The HS2 promised levels

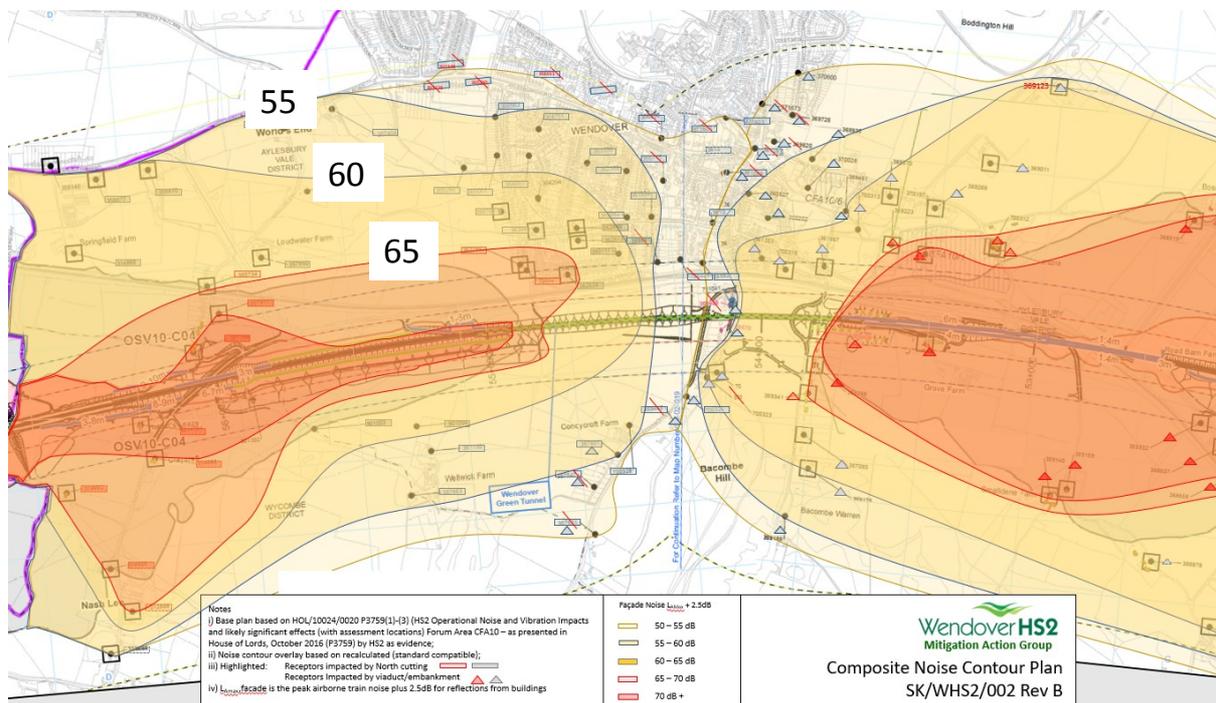
In the ES the [Noise profile maps](#) as shown to the Parliamentary Select Committees have a grey shaded area which suggests that the noise nuisance will be away from the main Wendover area. However this describes the 40dB average (LpAeq) night time contour rather than the 60dB peak (LpAFMax) impact, as defined in the [E20 information paper](#). This paper defines this as “60 LpAFMax (at the façade, from any nightly noise event)”.

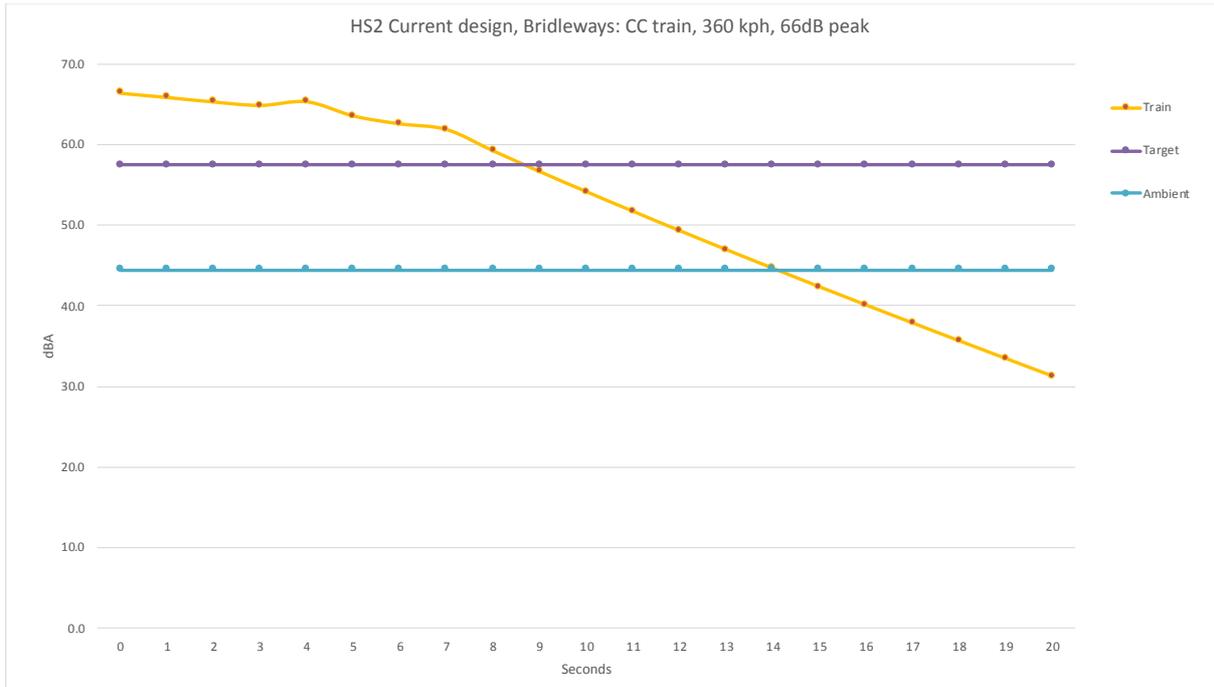
During ‘Phase 1’ operations HS2 plan to only use Conventional Compatible trains, and their assumption is that these will be 1dB noisier than the original [specification](#) (for HS2 trains). These are expected to operate at speeds of up to 360kph in the Wendover Green Tunnel, and E20 we need to allow for the ‘façade’ effect which adds 2.5dB. When we take these factors into account we can see a very different picture as shown below:

The yellow line in the following graph shows the “pass-by” noise levels at Bridleways (at the end of Lionel Avenue and Dobbins Lane) as a train heading north emerges from the green tunnel. The noise exceeds the purple target line (60dB façade) for 14 seconds. This is likely to be very intrusive, with a peak level of 66 dB being 22dB higher than the HS2 defined ambient level of 44dB shown by the blue line at night.

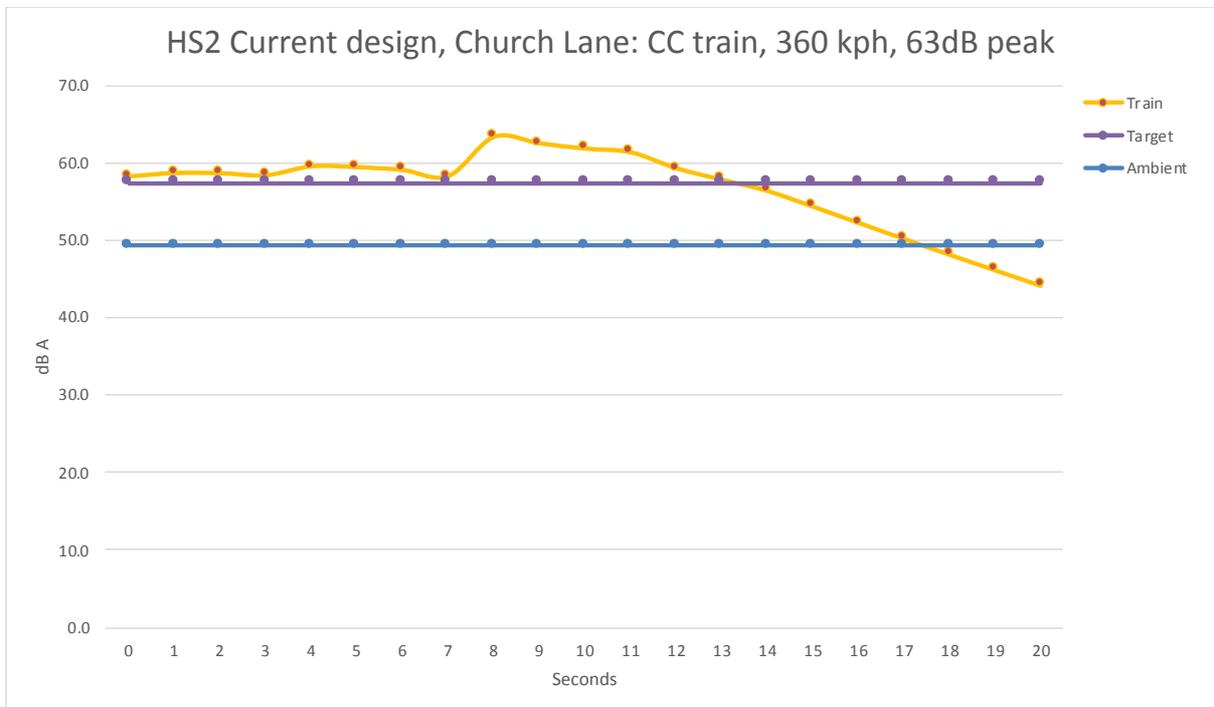
The next graph shows the similar pass-by profile at Church Lane near St Mary’s Church and the Chiltern Way Academy. The yellow line shows the noise levels as a train heading south emerges from the green tunnel on the Small Dean embankment and viaduct. The noise exceeds the purple target line (60dB façade) for 14 seconds. This is also likely to be very intrusive, with a peak level being 14dB higher than the HS2 defined ambient night level of 49dB shown by the blue line.

These graphs were produced by using the HS2 noise forecasting algorithm, and are subject to their “Standard Error” of +/- 3dB. This requires further explanation, as it relates to a statistical “standard deviation” as measured values are likely to diverge from the
